**Model  
Error Resolution Document**  
*Complete only applicable items.*

<b>1. Document Number:</b>	MDL-WIS-PA-000005	<b>2. Revision/Addendum:</b>	Rev 00 and AD 01	<b>3. ERD:</b>	ERD 05
<b>4. Title:</b>	Total System Performance Assessment Model/Analysis for the License Application				
<b>5. No. of Pages Attached:</b>	24

This Error Resolution Document (ERD) is provided to update the *Total System Performance Assessment for the License Application* (TSPA-LA) documents, including Rev 00, the addendum (AD 01), ERD 02 and ERD 04, to correct issues identified in the following condition reports (CRs). The corrections identified are necessary to add clarity and strengthen the discussion within the suite of TSPA-LA documents. There are no impacts on results or conclusions due to the clarifications and text revisions from the CRs listed below. CR 12543, however, will have an impact on the results from the TSPA-LA localized corrosion initiation analysis (Appendix O), but will have no effect on the overall model conclusions that are based on the calculation of repository performance.

Figure O-1. Fraction of Locations with the Potential for Localized Corrosion Initiation as a Function of Drip Shield Failure Time: (a) Bin1, CDSP; (b) Bin1, CSNF; (c) Bin2, CDSP; (d) Bin2, CSNF; (e) Bin3, CDSP; (f) Bin3, CSNF; (g) Bin4, CDSP; (h) Bin4, CSNF; (i) Bin5, CDSP; and (j) Bin5, CSNF

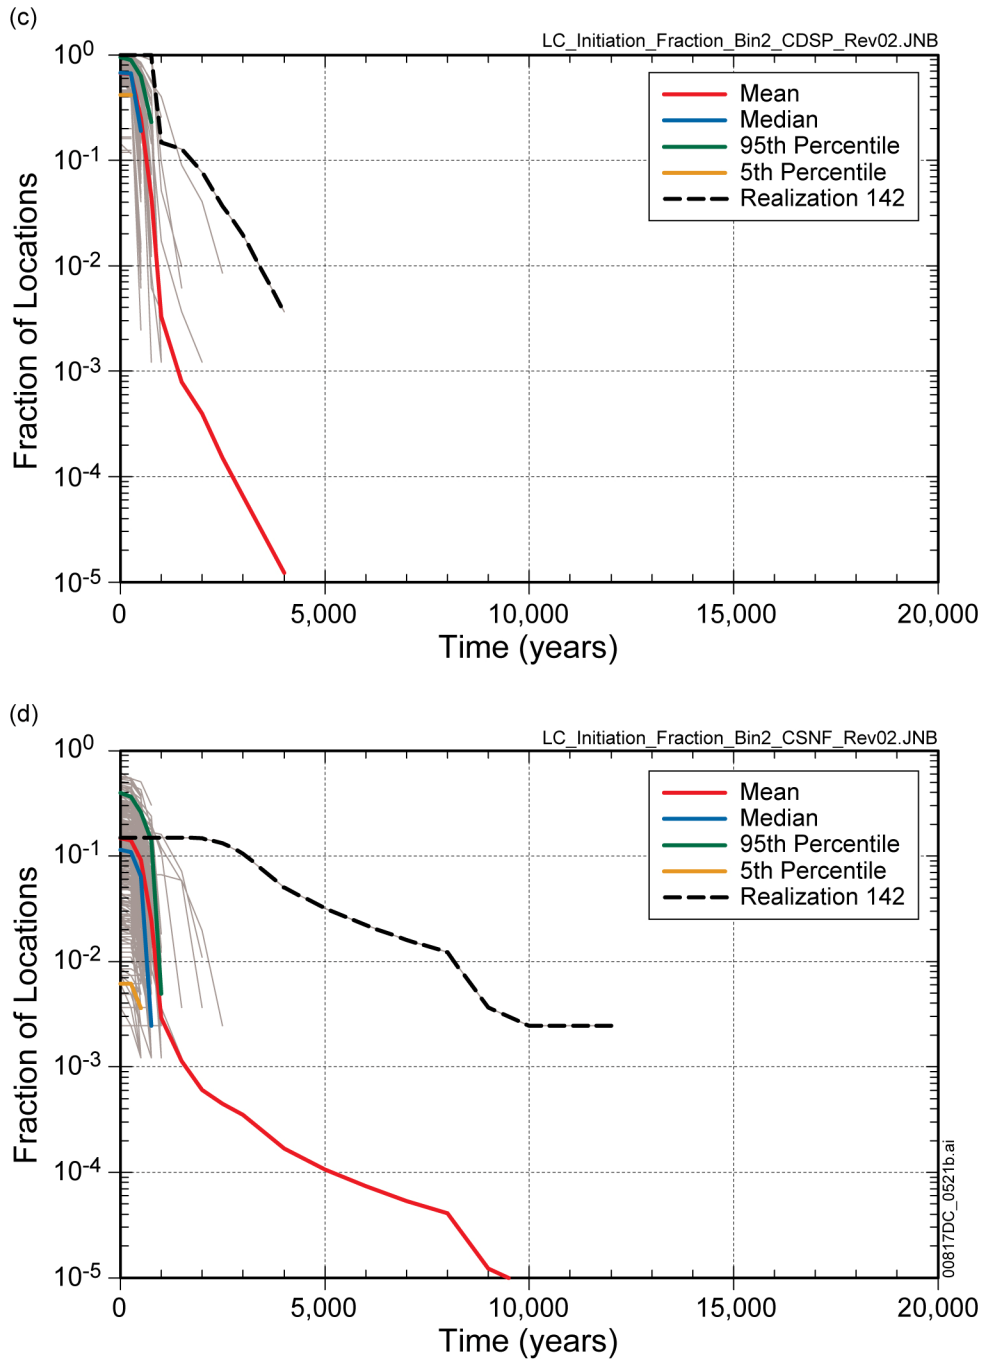
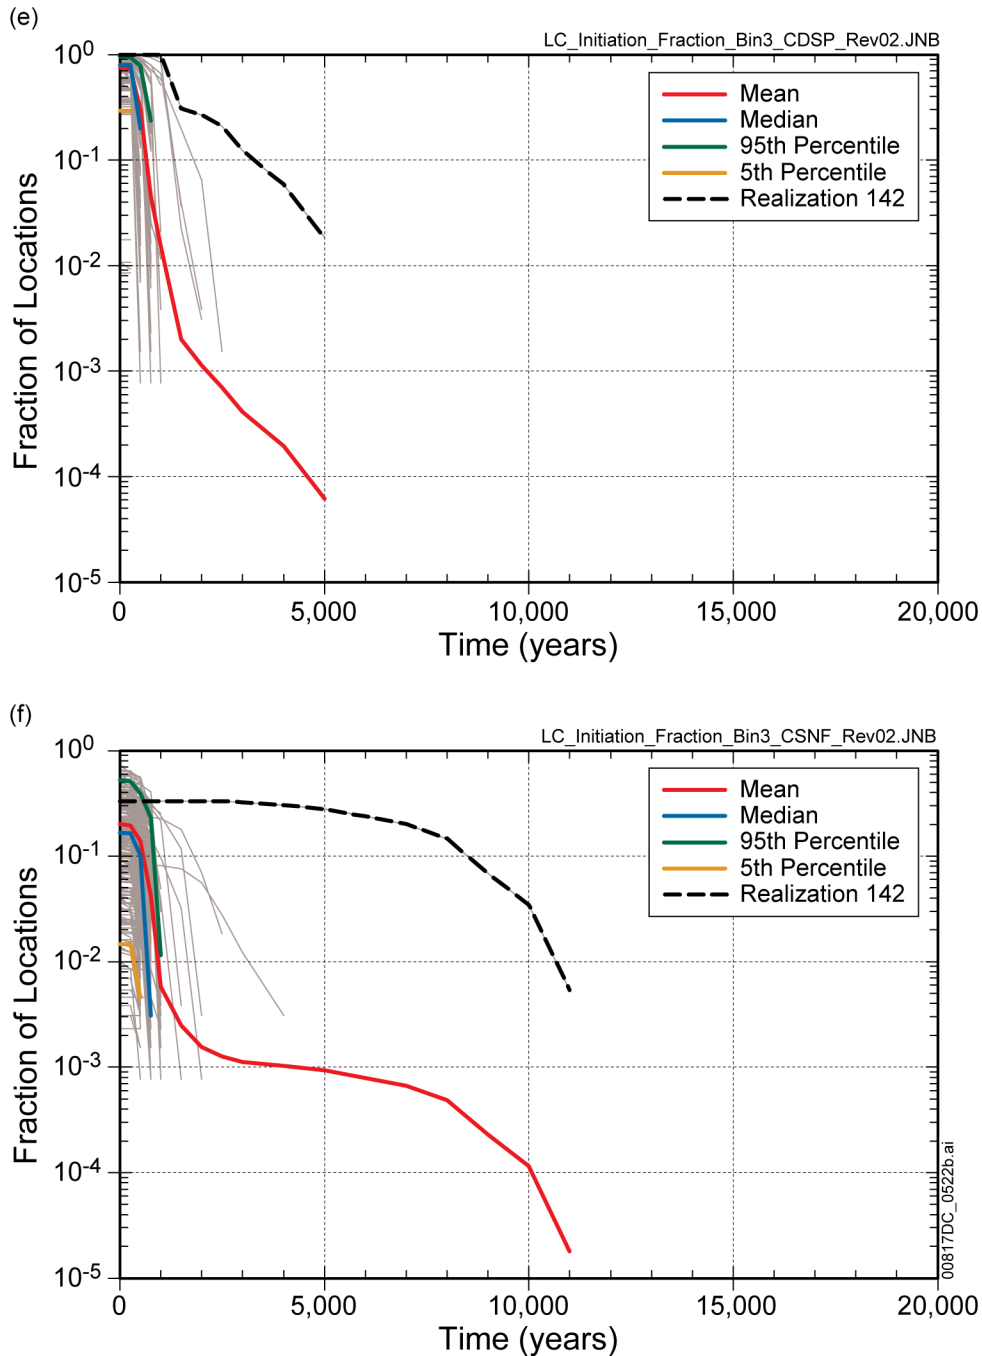
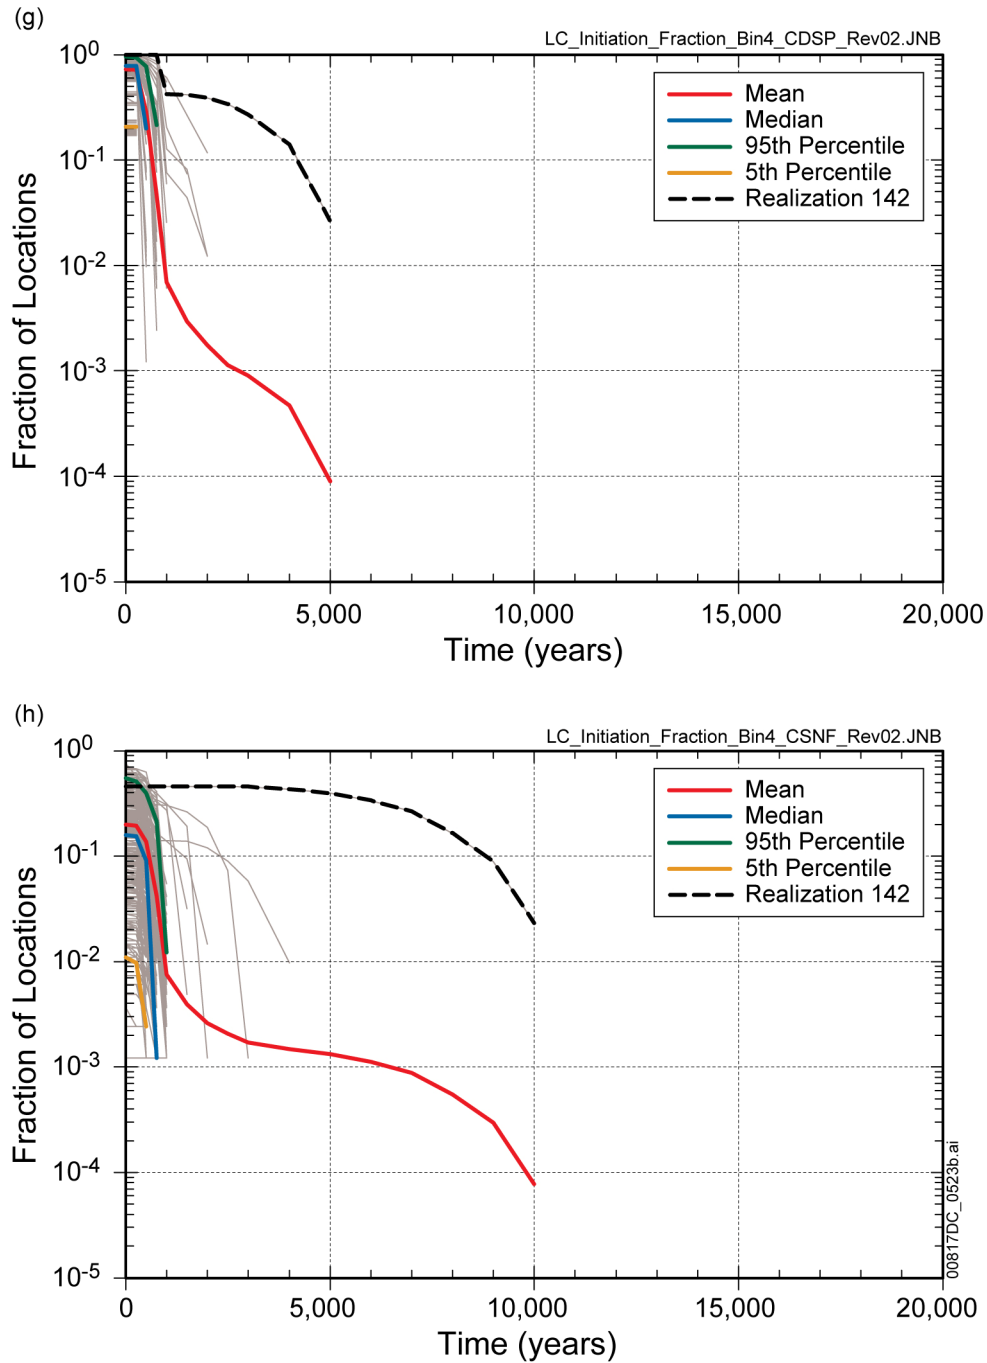
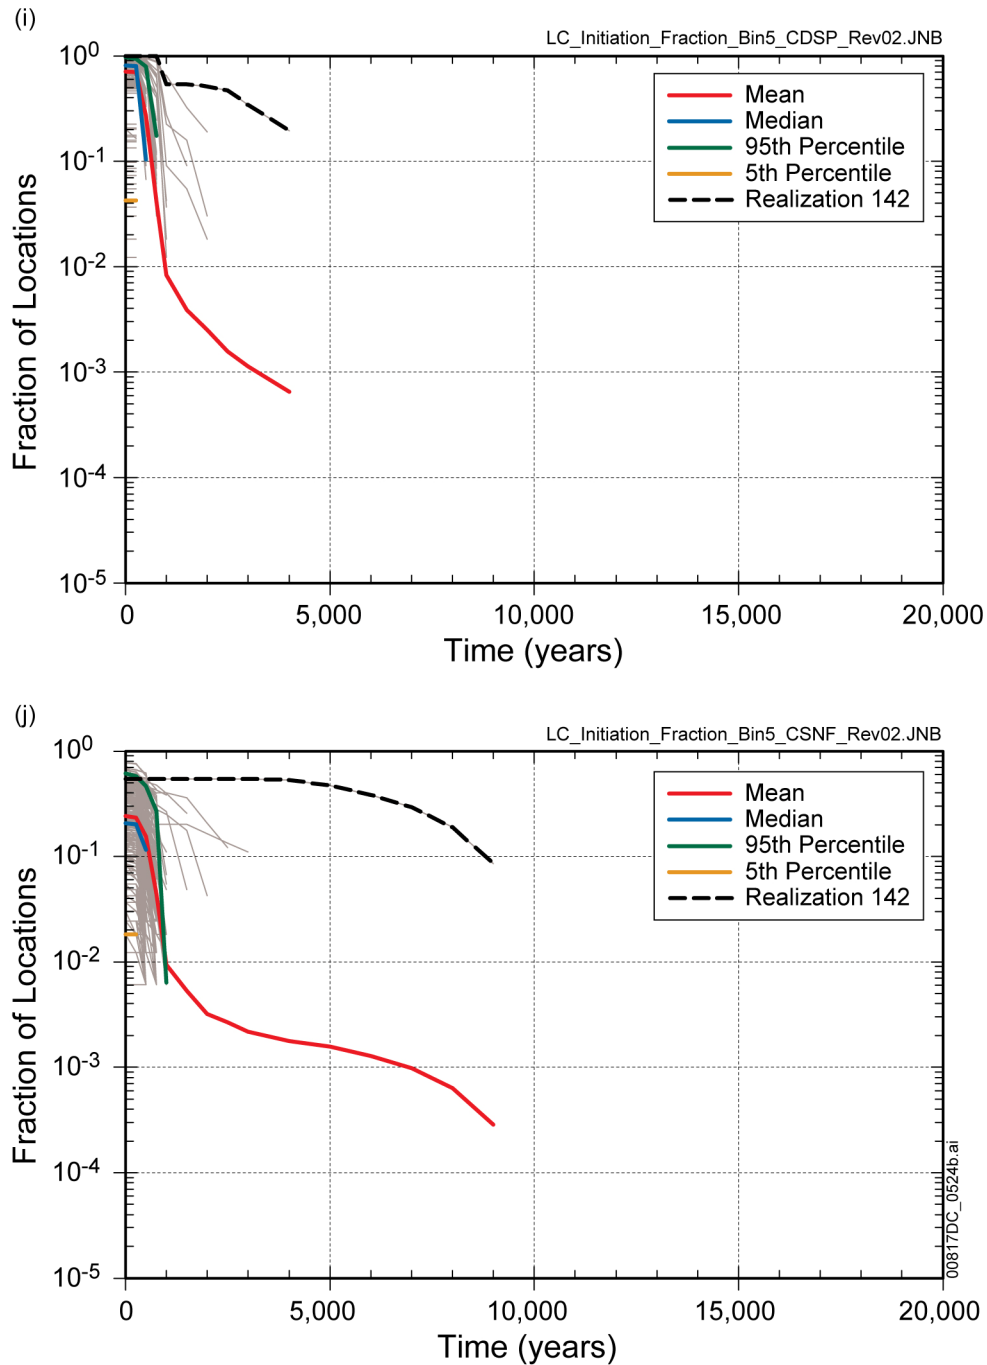
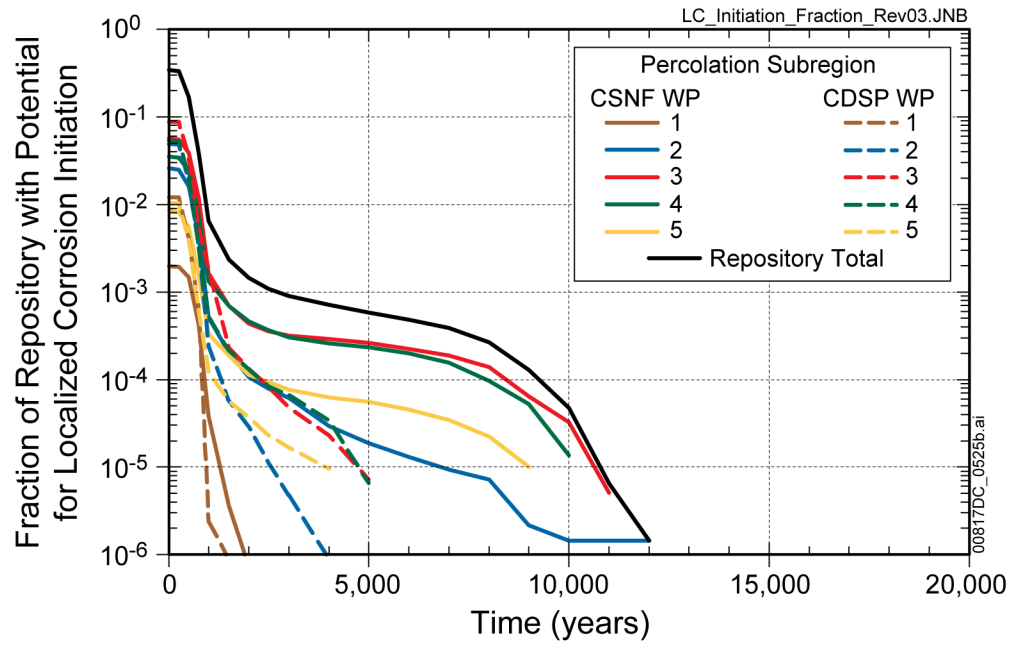
A new analysis has been completed with the appropriate implementation of localized corrosion being initiated from the occurrence of salt separation and the output DTN updated (MO0709TSPALOCO.000 [DIRS 185808]). This ERD updates the discussion presented in Appendix O of the parent document (Attachment 1), which is based on TSPA-LA Model v5.000 (output DTN: MO0709TSPAREGS.000 [DIRS 182976]) with results from the new analysis and dose histories from TSPA-LA v5.005 (output DTN: MO0710ADTSPAWO.000 [DIRS 183752]). The original dose analysis evaluating the impact of localized corrosion in the Seismic Ground Motion Modeling Case for 10,000 years (DTN: MO0708FREQCALC.000 [DIRS 183006]) presented in Section 7.3.2 of the parent document has also been updated (Attachment 2) with the corrected localized corrosion model results and TSPA-LA v5.005 dose histories from output DTN: MO0710ADTSPAWO.000 [DIRS 183752]. Attachment 2 contains a replacement for TSPA-LA Figure 7.3.2-17; however no modification to the text was required. Attachment 3 contains areas in the document which should be revised to reflect the new localized corrosion DTN.

**ATTACHMENT 1—REPLACE APPENDIX O (CR 12543)****01. INTRODUCTION**

In the table of contents, update the figure caption of Figures O-1 and O-2.

Figure O-2. Fraction of Locations in Each Percolation Subregion with the Potential for Localized Corrosion Initiation after the Drip Shield Fails as a Function of Drip Shield Failure Time

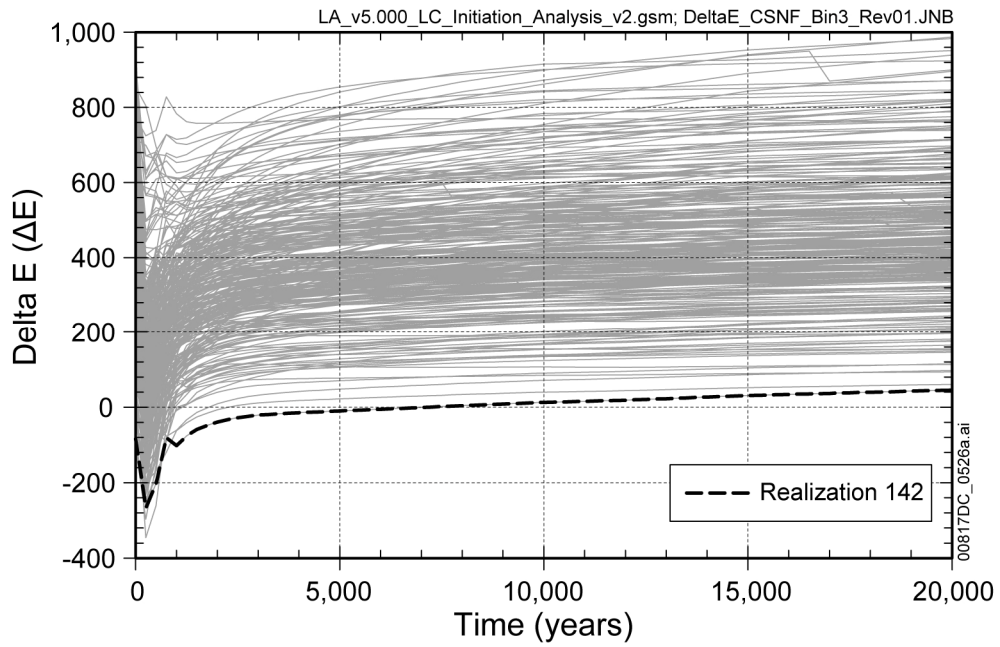
Figure O-2 shows the average fraction of all WPs that could potentially experience localized corrosion, computed by multiplying each of the mean curves on Figure O-1 by its respective bin fraction (0.05, 0.25, 0.40, 0.25, and 0.05) and its WP type fraction (3416/11629 for CDSP WP and 8213/11629 for CSNF WP). There are more CSNF WPs and they are hotter so CSNF WPs comprise a larger fraction of the total number of WPs that could experience localized corrosion. The repository total curve shows the mean fraction of WPs with potential for localized corrosion for the entire repository. The average fraction of WPs on which localized corrosion may potentially initiate peaks at about 0.34 for the first few hundred years after closure when the repository is hot, and highly concentrated solutions exist on the WP surface. Of the 0.34 fraction, about 0.1 is from the corrosion potential only and the remainder is from the chloride rich brine resulting from salt separation (or both). After a few thousand years, the fraction of WPs with the potential for localized corrosion initiation decreases to below  $10^{-3}$ .

Figure 7.3.2-17. Expected Annual Dose Over 10,000 Years from Seismic Ground Motion Events that Result in Drip Shield Plate Failure

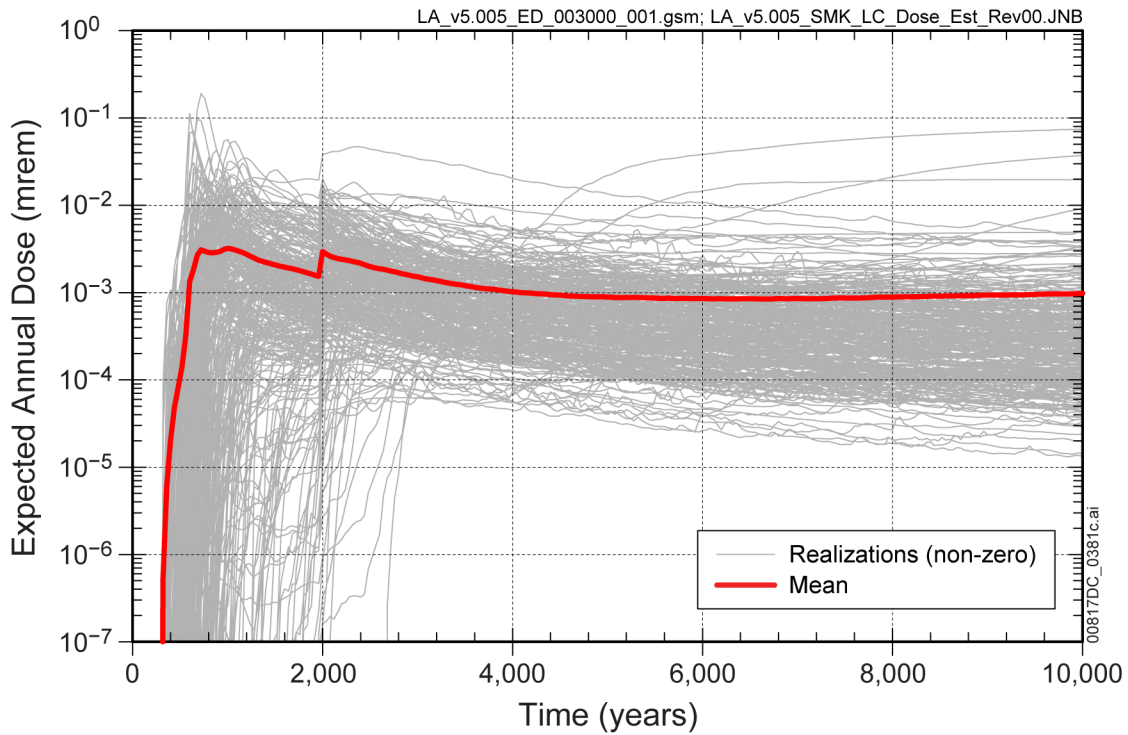
**ATTACHMENT 2—REPLACE FIGURE 7.3.2-17 ON PAGE F7.3.2-17**

Source: Output DTNs: MO0710ADTSPAWO.000 [DIRS 183752]; and MO0709TSPALOCO.000 [DIRS 185808].  
 NOTE: This figure has been updated to use dose data from v5.005 of the TSPA-LA Model.

Figure B-1. Road Map of TSPA-LA Model Data Tracking Numbers

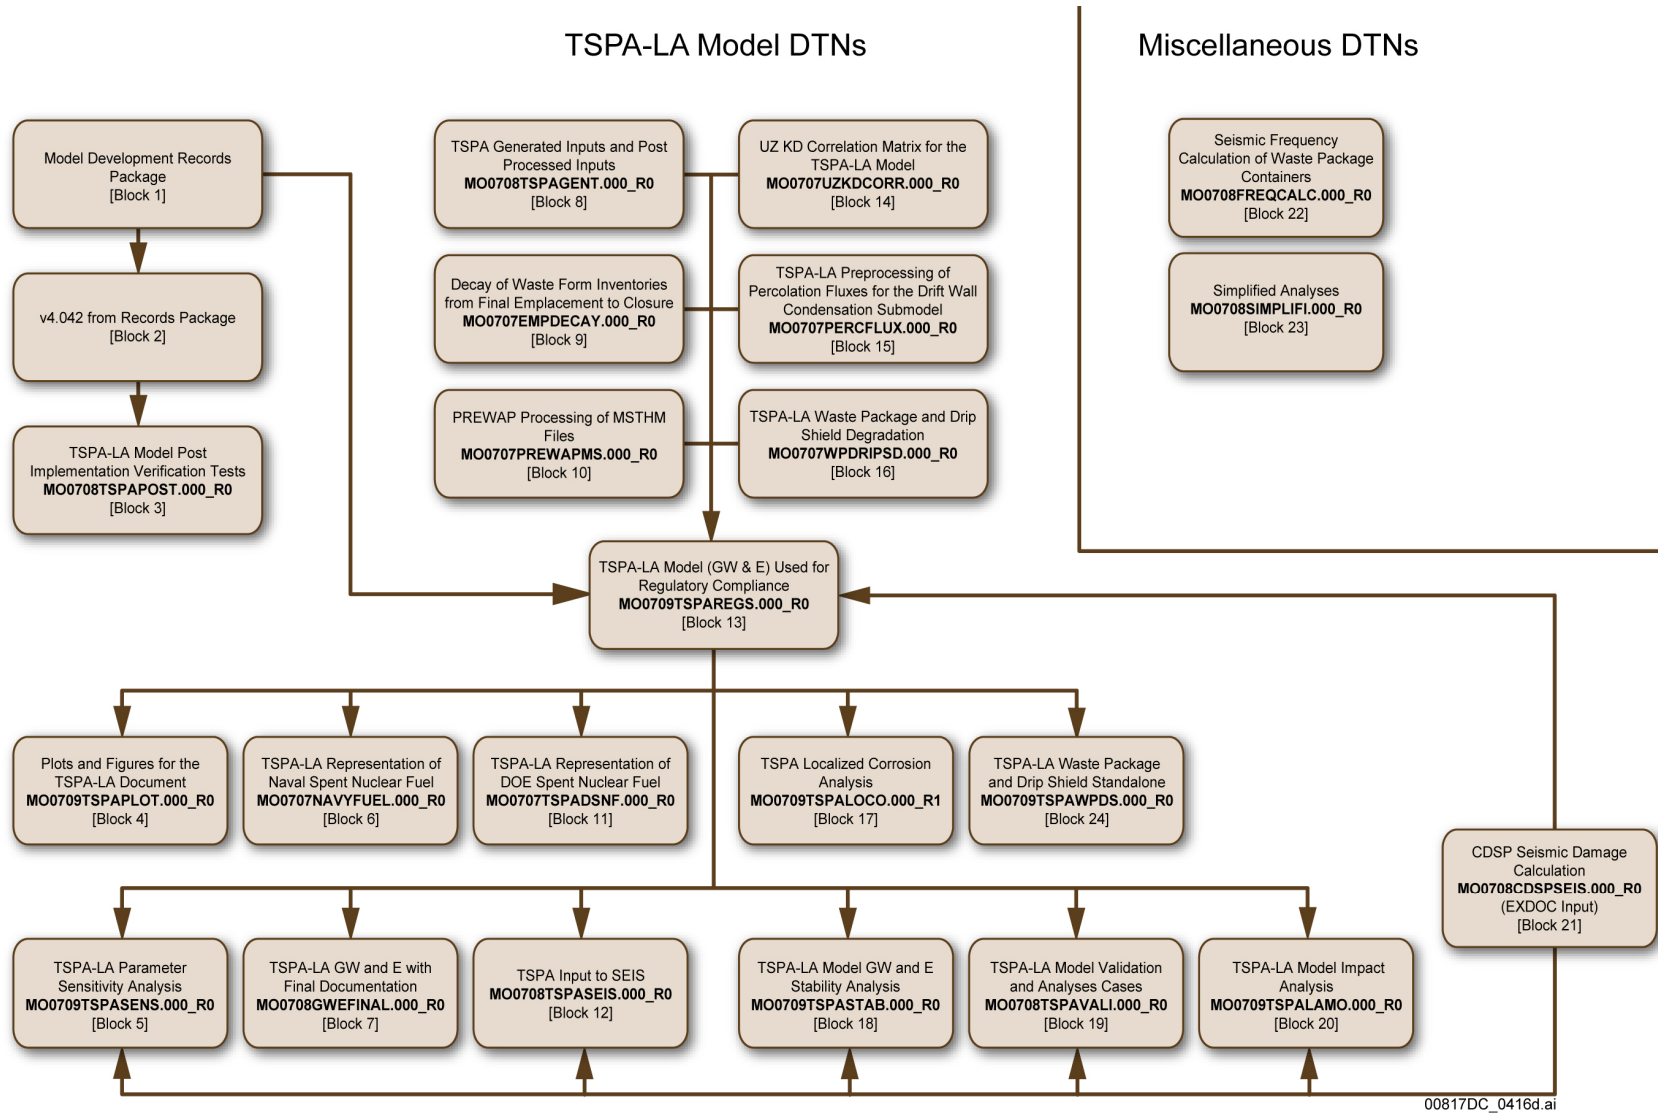
Replace Figure B-1 in order to revise the DTN reference in Block 17 (page B-9):

**Reference Figure B-1, Block 17**—This DTN contains the GoldSim runs that are used to confirm that localized corrosion is addressed by the Compliance Model that is documented in output DTNs MO0709TSPAREGS.000 [DIRS 182976] and MO0710TSPAWO.000 [DIRS 183752].
